SUBJECT: Calvert Cliffs Nuclear Power Plant
Unit Nos. 1 & 2; Docket Nos. 50-317 & 50-318
Supplemental Data for Request for Relaxation from Certain Inspection Requirements in NRC Order (EA-03-009) for Reactor Pressure Vessel Head Penetration Nozzles (TAC Nos. MB7752 and MB7753)

RESPONSE TO REQUEST FOR ADDITIONAL INFORMATION AND REACTOR PRESSURE VESSEL HEAD UT EXAMINATION RESULTS

ADDITIONAL RELAXATION REQUEST

FIGURE 1

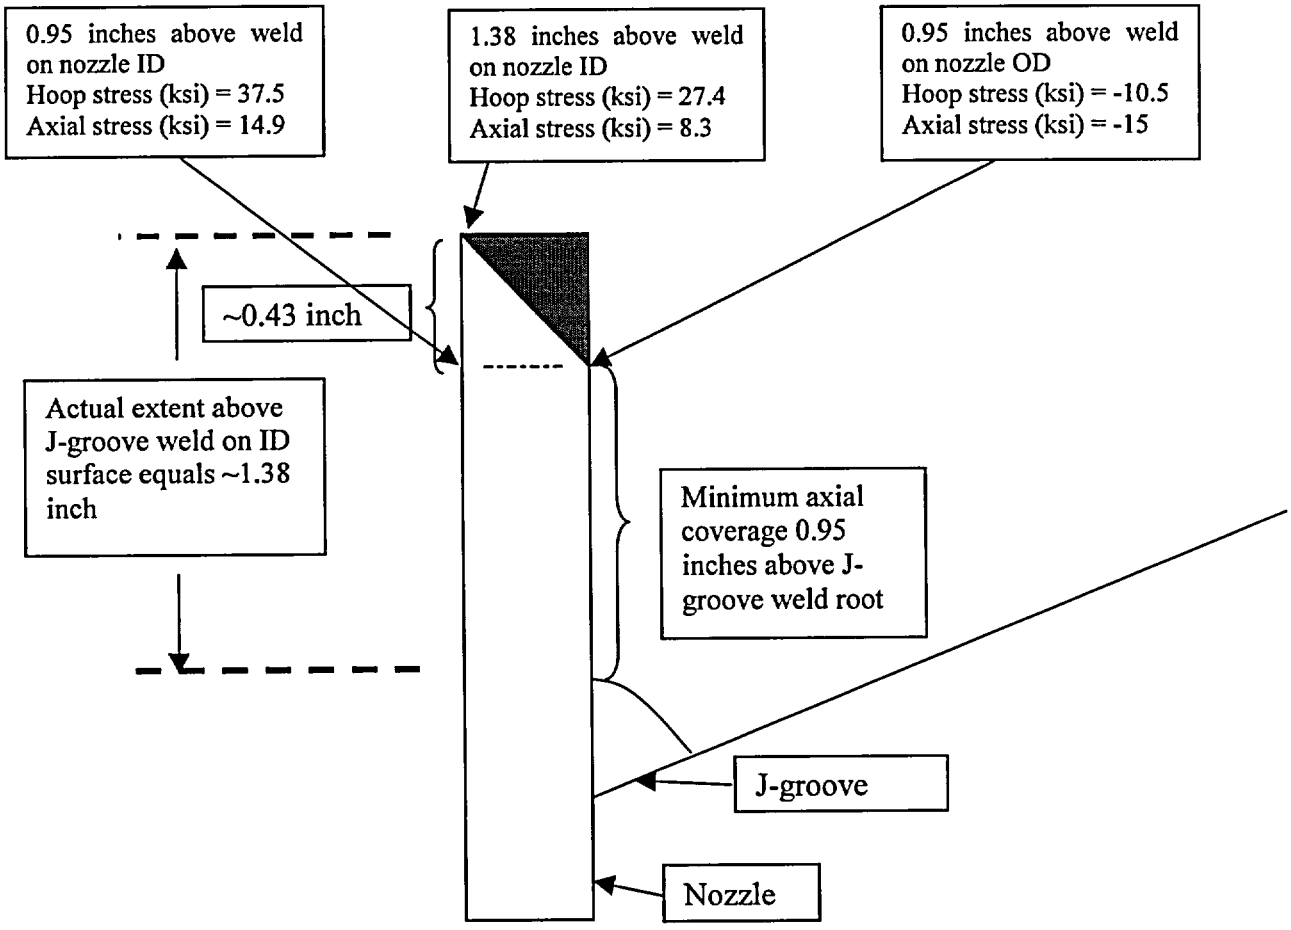
Provide the bounding hoop and axial stresses present at the location of lowest coverage above the J-groove weld.

The requested information is provided on Figure 1 below. The bounding value is located on Nozzle 43 which had coverage to 0.95 inches above the root of the J-groove weld. Nozzle 43 has a 38.5 degree angle with the head. Calculated stresses are reported for a 42.5 degree nozzle, which bounds a 38.5 degree nozzle. Stresses are provided at three locations: on the outside diameter (OD) at the elevation of highest coverage, on the inside diameter (ID) at the same elevation, and on the ID at the elevation of highest coverage. Coverage elevations above the J-groove weld have been reported for coverage on the OD. In all cases coverage on the ID is higher. This is due to the configuration of the transducers in the blade probe and is analogous to the situation at the bottom of the nozzle (see Figure 1 in Attachment 2). Further discussion on the configuration of the transducers in the blade is contained in Attachment (2).

Bounding hoop and axial stresses at elevation of minimum coverage extent above the root of the J-groove weld occurs on Nozzle 43

FIGURE 1

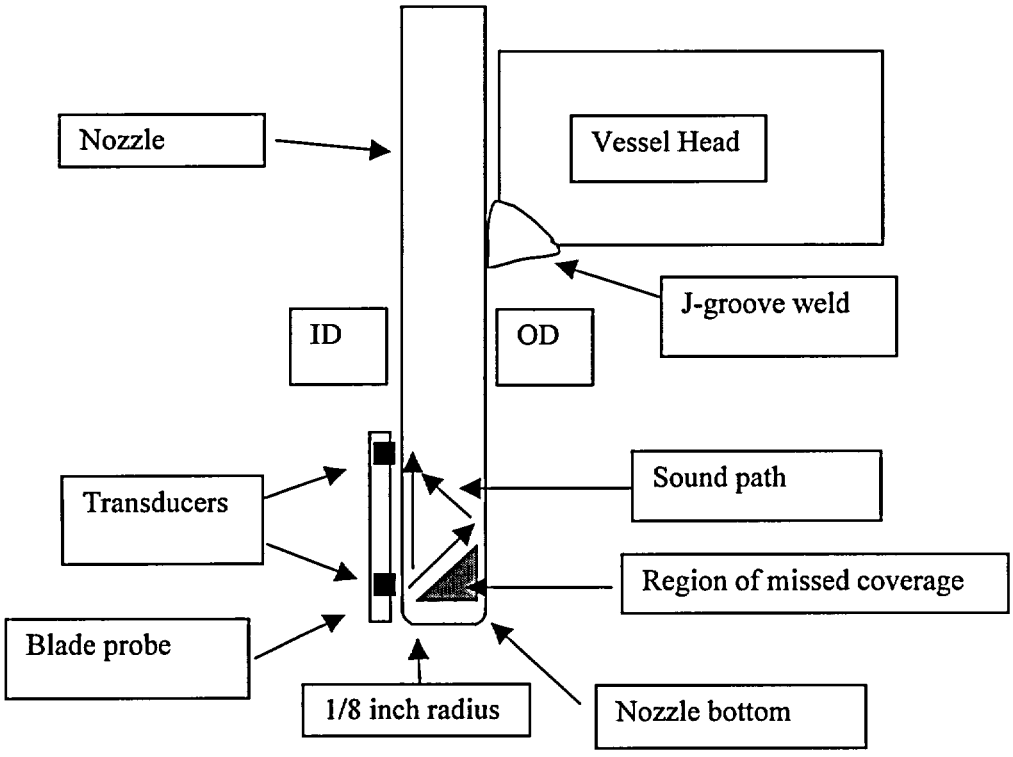
This relaxation request applies to all Calvert Cliffs Nuclear Power Plant Unit 2 CEDM penetrations 1 through 65. The un-interrogated area at the bottom end of the CEDM nozzles is due to the configuration of the ultrasonic transducers in the probes used to examine the nozzles. These probes have separate transducers for sending and receiving the ultrasonic signal. The probes, used for detection of the most significant type of cracks, circumferential cracks, have the two transducers arranged one above the other. The transducers used in the CE-type circumferential blade probe are located nominally 0.86-inch apart. With this configuration, the lower transducer will not contact the inside wall on the nozzle until the upper transducer is inserted greater than approximately 0.86-inch into the nozzle. Since the scanning process requires that both transducers be in contact with the surface, the probe cannot scan a small portion of the bottom of the nozzle. Based on the geometry involved in the transducer location and nozzle configuration, the portion that cannot be scanned is the portion extending from the bottom of the nozzle upward for a distance of approximately 0.56-inch. The value is half the distance between the two transducers plus a 1/8-inch radius at the bottom corner of the nozzle. The actual volume of unobtainable coverage is triangular in cross-section. The inside diameter of the nozzle receives relatively complete coverage (with a lateral wave), while the UT angle defines a triangle hypotenuse extending from the nozzle inside diameter lower end, to a spot on the nozzle outside diameter, located approximately 0.56-inch above the bottom of the nozzle. The other legs of the triangle are the lower portion of the nozzle outside diameter and the bottom surface of the nozzle. Figure 1 illustrates the un-interrogated area.
